# HISTORIC AND DESIGN REVIEW COMMISSION

**HDRC CASE NO:** 2020-252  
**ADDRESS:** 328 E JOSEPHINE  
**LEGAL DESCRIPTION:** NCB 975 (BOEHLER'S SUBD), BLOCK 18 LOT 15  
**ZONING:** C-3, RIO-2  
**CITY COUNCIL DIST.:** 1  
**APPLICANT:** Kristen Weber/Don B. McDonald, Architect  
**OWNER:** RIO PERLA PROPERTIES LP  
**TYPE OF WORK:** Amendments to a previously approved design, new construction, site work  
**APPLICATION RECEIVED:** June 12, 2020  
**60-DAY REVIEW:** Not applicable due to City Council Emergency Orders  
**CASE MANAGER:** Edward Hall  
**REQUEST:**

The applicant is requesting a Certificate of Appropriateness for approval to amend a previously approved design. Within this request, the applicant has proposed the following:

# Boehler's House Revision

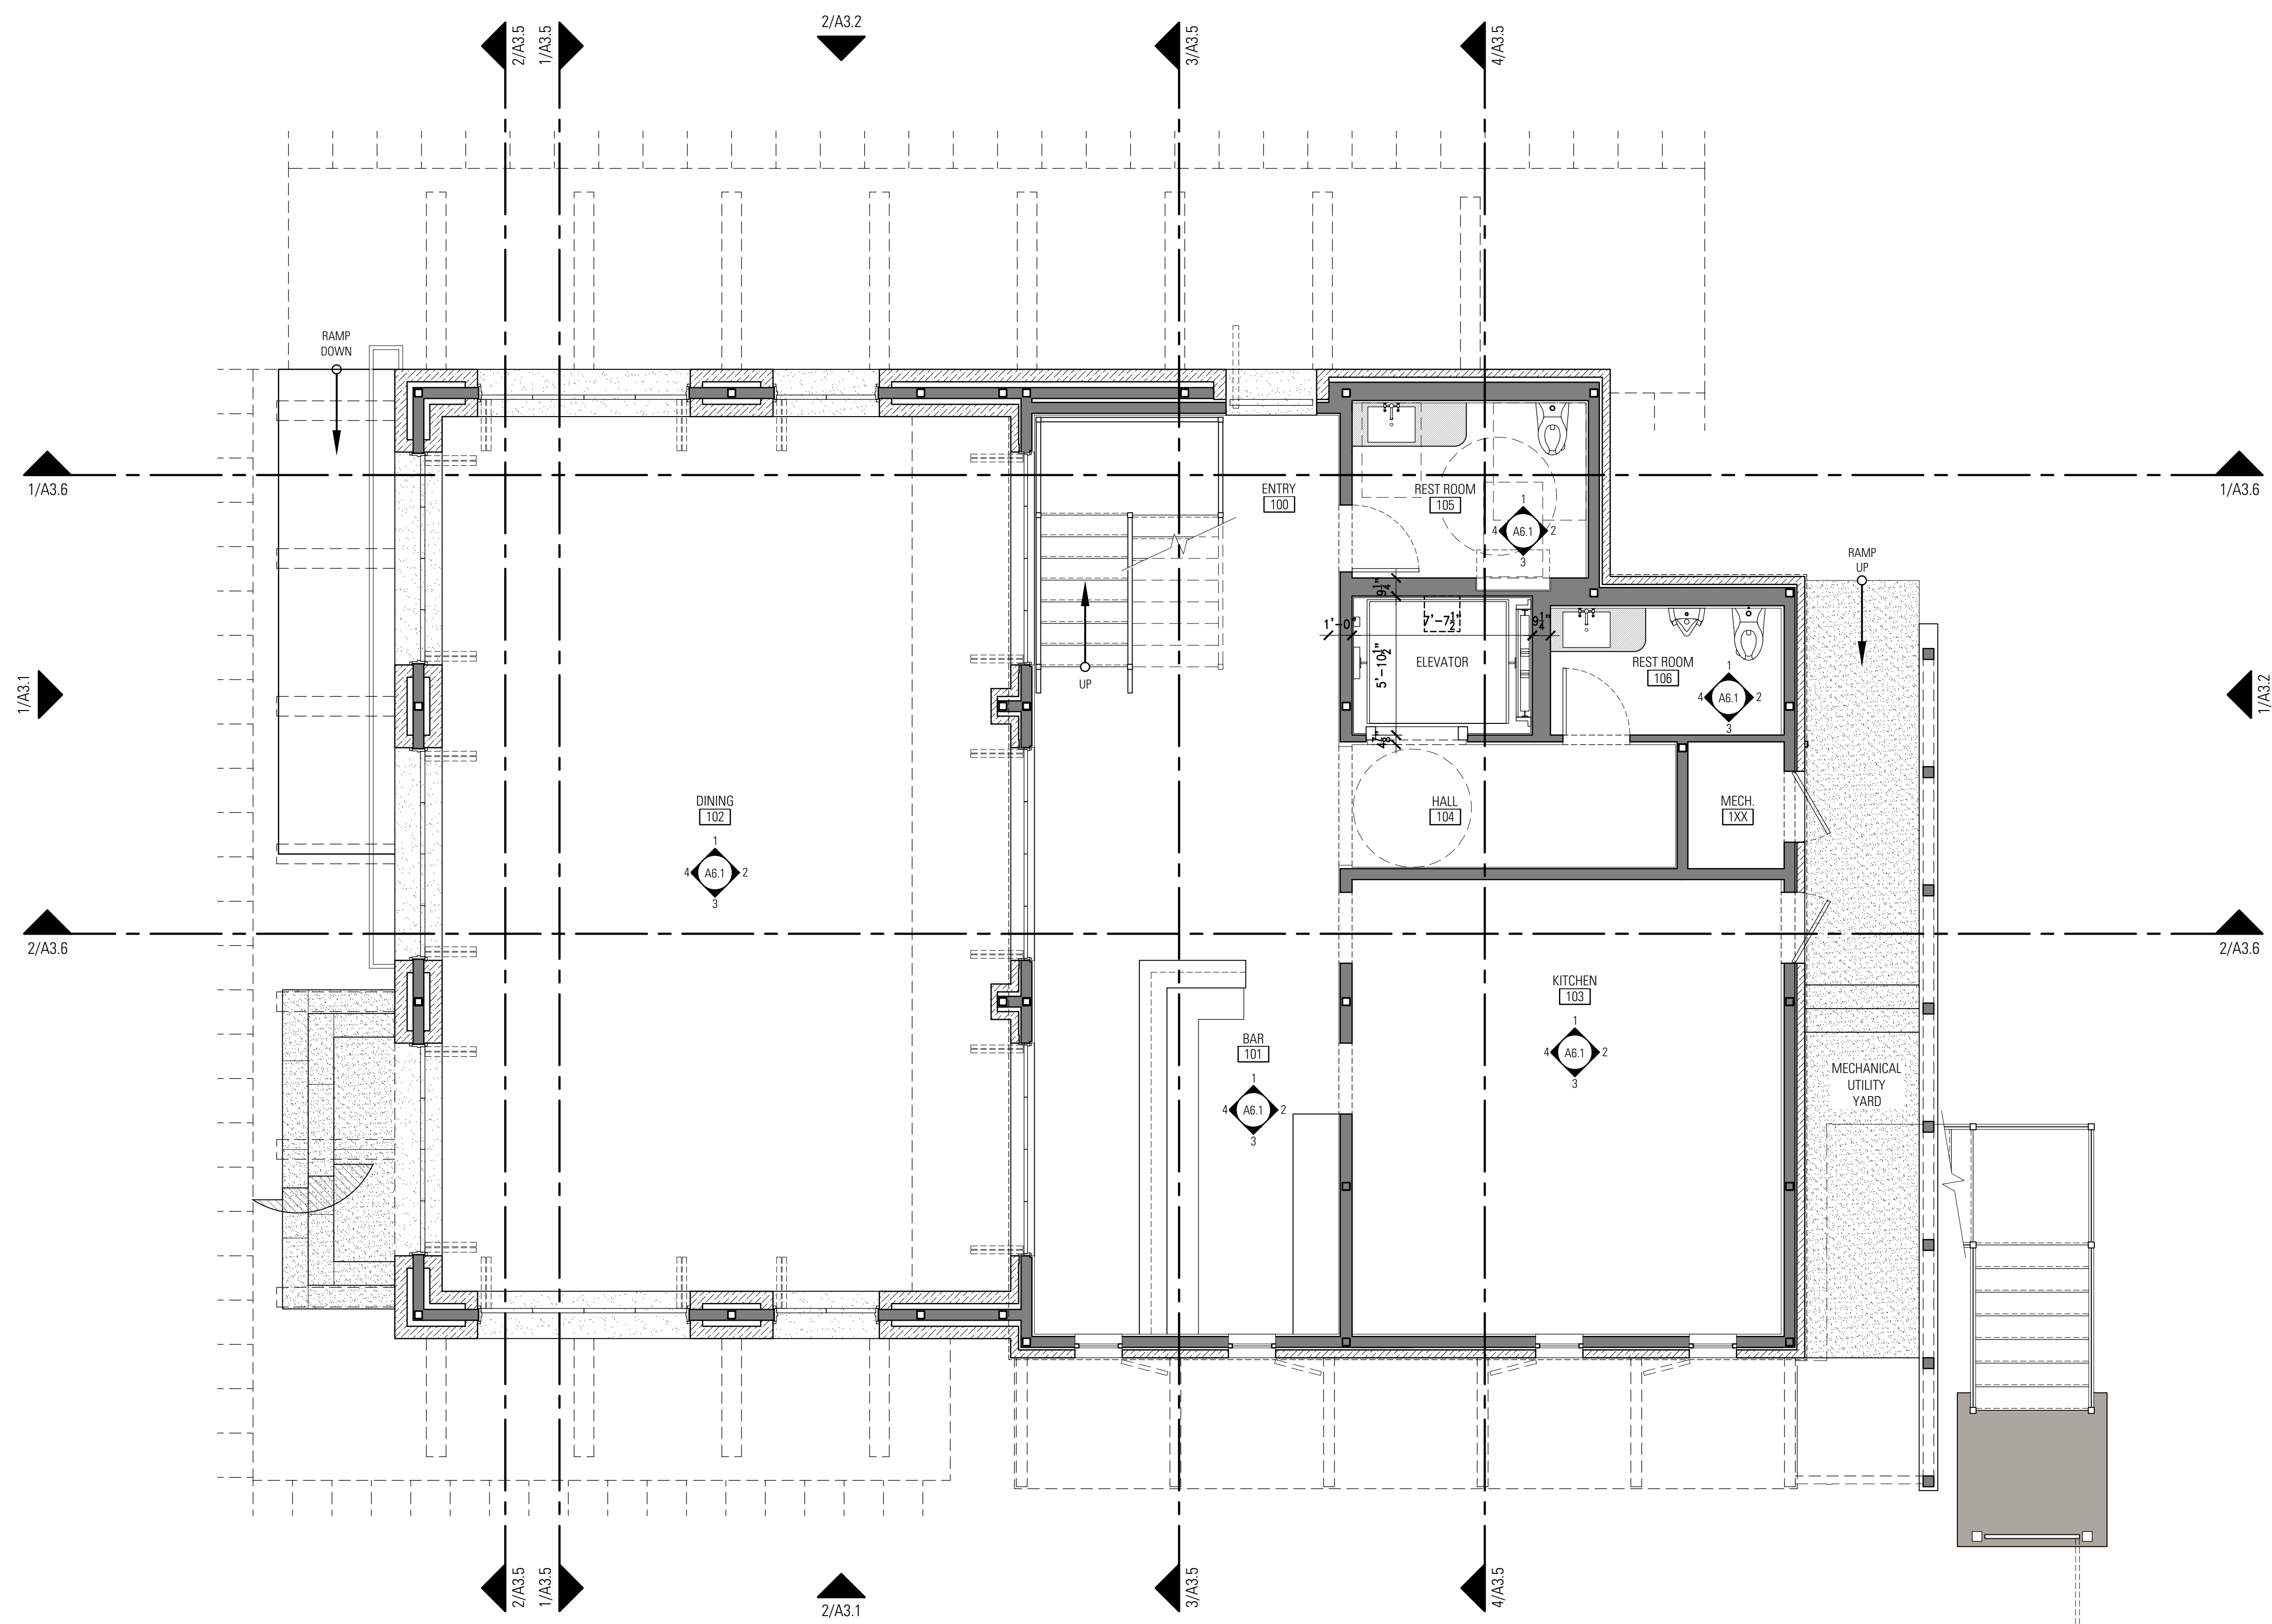
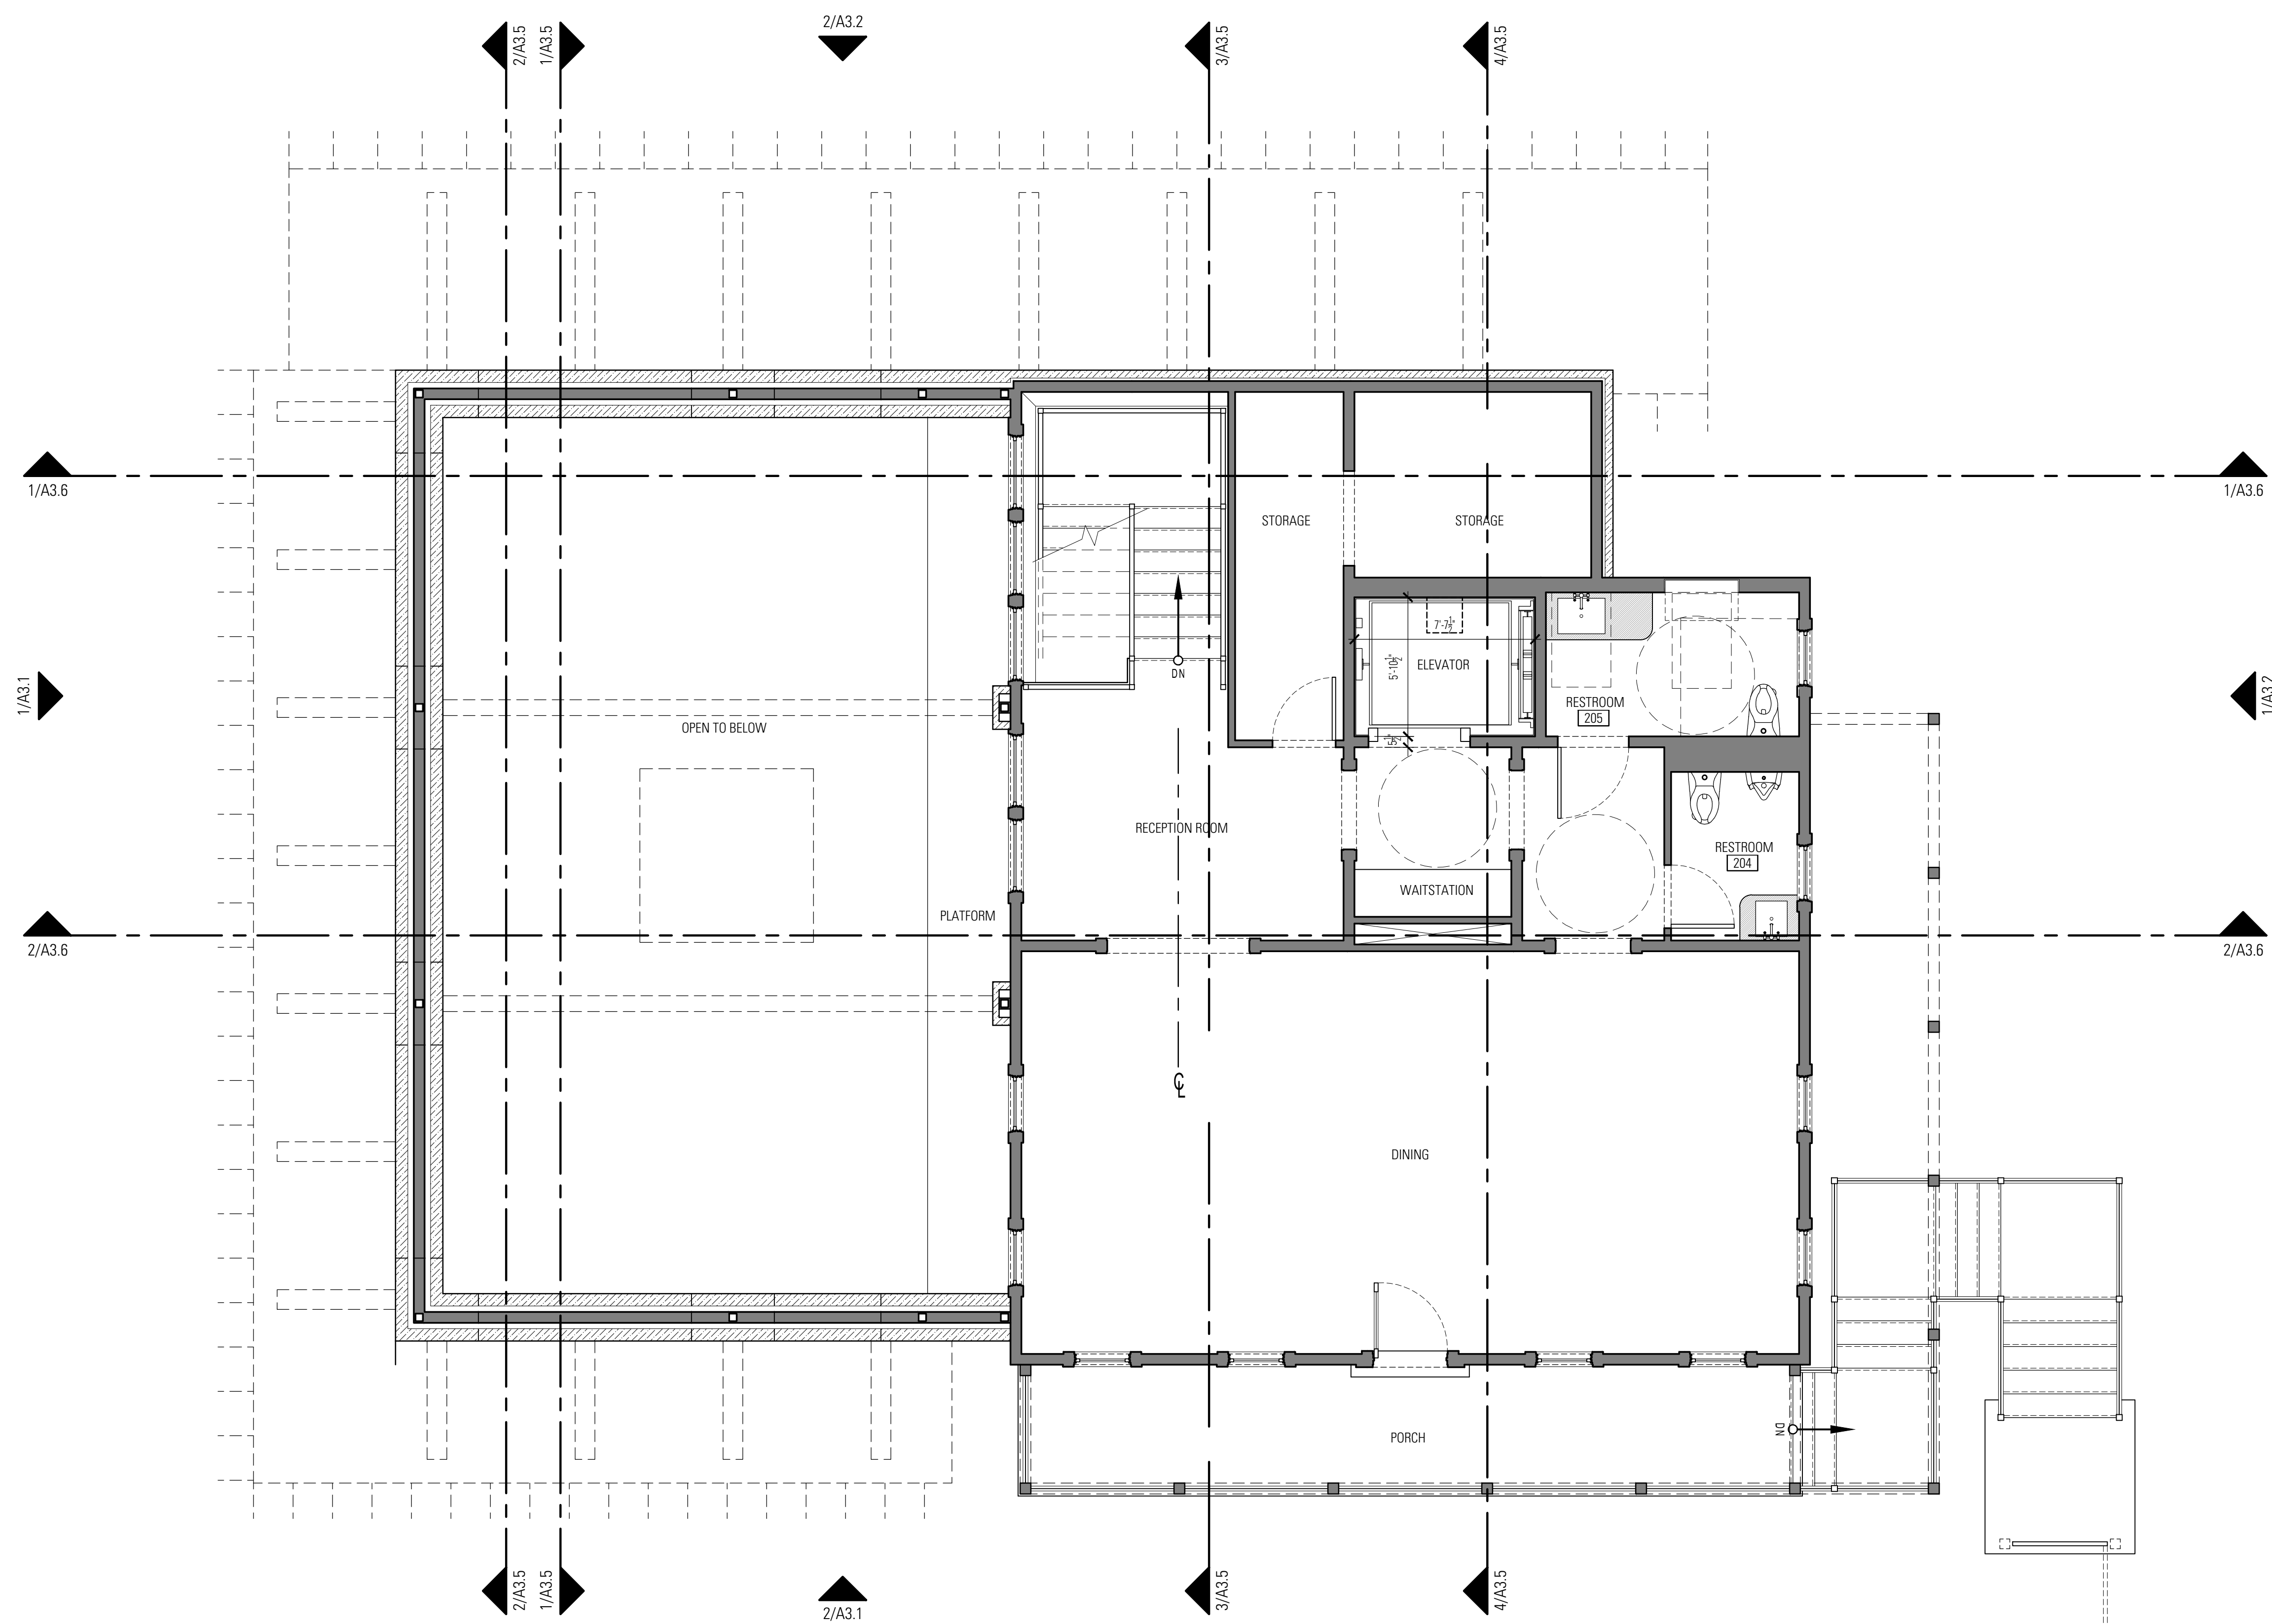
3. Construct a restaurant structure utilizing the doors, windows, exterior materials, chimney brick and interior siding of the Boehler's House, where feasible. The Boehler's House will be demolished.

- d. NEW CONSTRUCTION – The applicant has proposed to construct a new restaurant structure to replace the existing structure, commonly known as Boehler's House. The applicant has proposed to demolish Boehler's House, and to construct a new structure using the doors, windows, exterior materials, chimney brick and interior siding of the Boehler's House, where feasible. The Boehler's House is not a designated historic property and is eligible for demolition. If the HDRC approves the request as proposed, a demolition permit will be issued administratively by staff.

The initial plan to raise and restore Boehler's House proved to be too inefficient and costly. The new plan is to salvage all Doors, Windows, Exterior, Chimney brick and Interior Siding where possible. Rather than recreate a replica of the generic cottage, the new proposal utilizes the salvaged materials to create a structure that speaks directly to the San Antonio raised cottage vernacular. Equally important, a long narrow porch overlooking Avenue A reinforces the character of the street when Boehler's stood at the corner.
